Preface

This Field Safety Notice (FSN) contains important customer information for patient safety and for the safe use of *exoplan*, our software for implant planning and surgical guide design.

Internal exocad Reference: #322799

exocad product, commercial name: *exoplan*

Figure 1: Sketch comparing the distance situation between sleeve, implant and drill for the wrongly entered drill (left) and the correct drill (right).

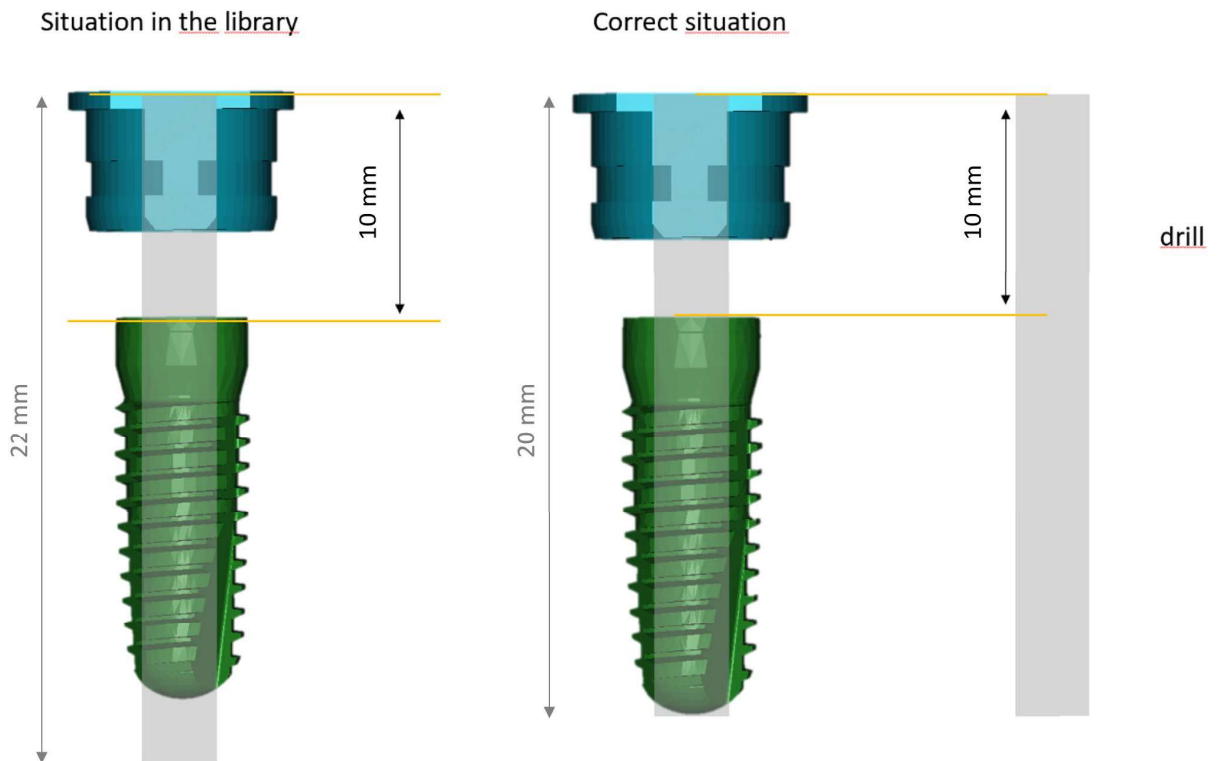
The issue is an incorrect specification in the Argon_Rapid_Surgery_sleeve libraries, suggesting the use of a surgical drill that results in a 2 mm deeper drill hole than expected due to a dimensional error in the affected libraries.

During an update of data used in a library shipped with *exoplan* or made available on the download portal of exocad, it was found that the use of a specific combination of an implant, sleeve and surgical drill can result in a hole being drilled 2 mm deeper than expected.

The identified issue in the Argon Sleeve Library, where incorrect drill length information is reported, poses significant risks to patient health during dental implant surgeries. Specifically, the software indicates a drill length that is 2 mm longer than necessary. The software provides a default safety margin of 1.5 mm, which as a result of the incorrect drill length information, is insufficient, as it is also shifted by 2 mm. This error can lead to over drilling beyond the intended surgical boundary.

- 4) New library version of Argon_Rapid_Surgery_sleeve have been released (<SignatureDate>2024-05-07T14:47:36.6611068Z</SignatureDate>). Users can now download and install the new libraries.

- 1) Do not use the affected libraries - see section “Affected libraries” above.
- 2) Download the new libraries at <https://exocad.com/integration/exoplan-library-integration> or use exocad *Library Manager* from within *exoplan*.

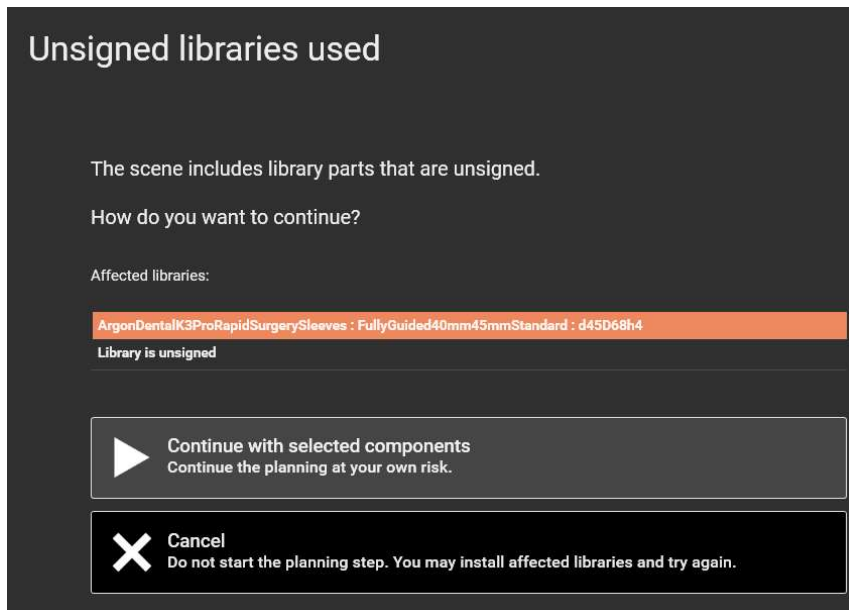
- 2) As a result of the blacklisting, if the user tries to select a component in the affected library, the user receives a message indicating that the selected sleeve library is marked as “unsigned” and should no longer be used. This message appears when the user selects the blacklisted library, as well as before the implant planning and surgical guide output data is generated. Users notified by this warning should click “cancel” and not “continue”. If users click continue, they continue at their own risk.

Figure 3: Unsigned library message of a blacklisted Argon® library to the user when loading a scene file that already contains the affected library.

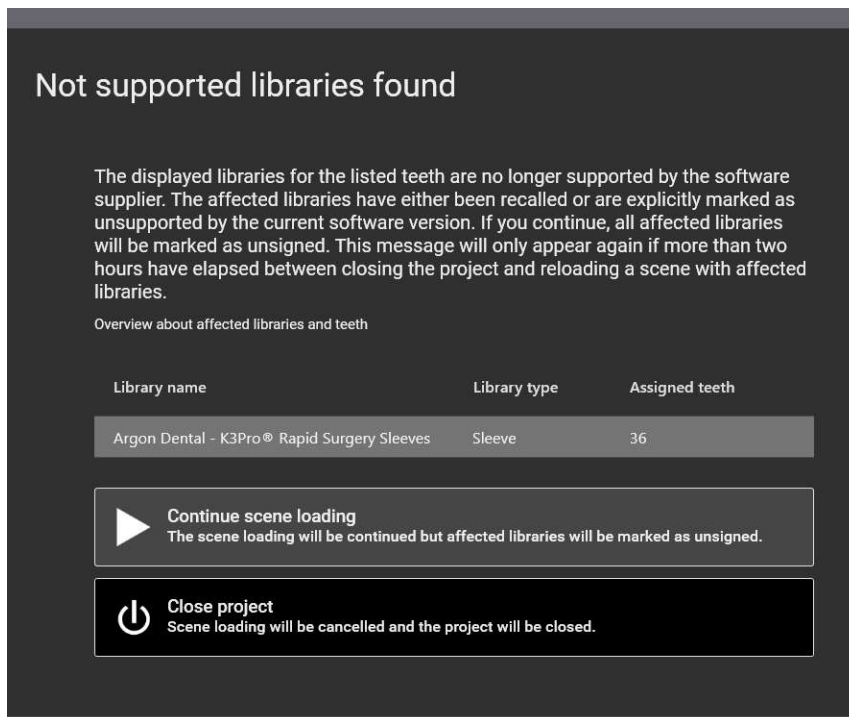
- 3) If an implant planning “scene file” (file containing all the information about a planning or design scene, e.g., workflow state, scene objects) is loaded into *exoplan* that previously used the blacklisted sleeve library in the implant placement planning, a warning message appears to inform the user about the unsigned library (see figure 3).
